**CENTER FOR DRUG EVALUATION AND
RESEARCH**

APPLICATION NUMBER:

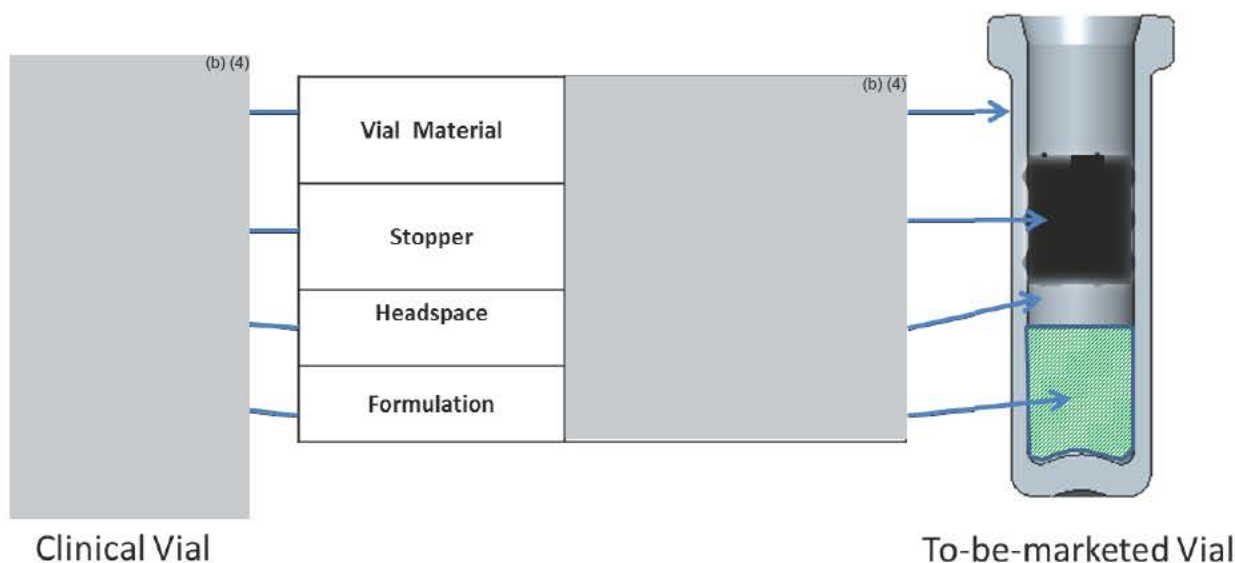
FDA Response: We agree with your proposal to fill and assemble (b) (4) nasal spray units out of (b) (4) units of each dosage strength, and use them as the primary stability batches (three batches for each dosage strength). (b) (4)
(b) (4) The primary stability batches should be filled into the “to-be-marketed” device.
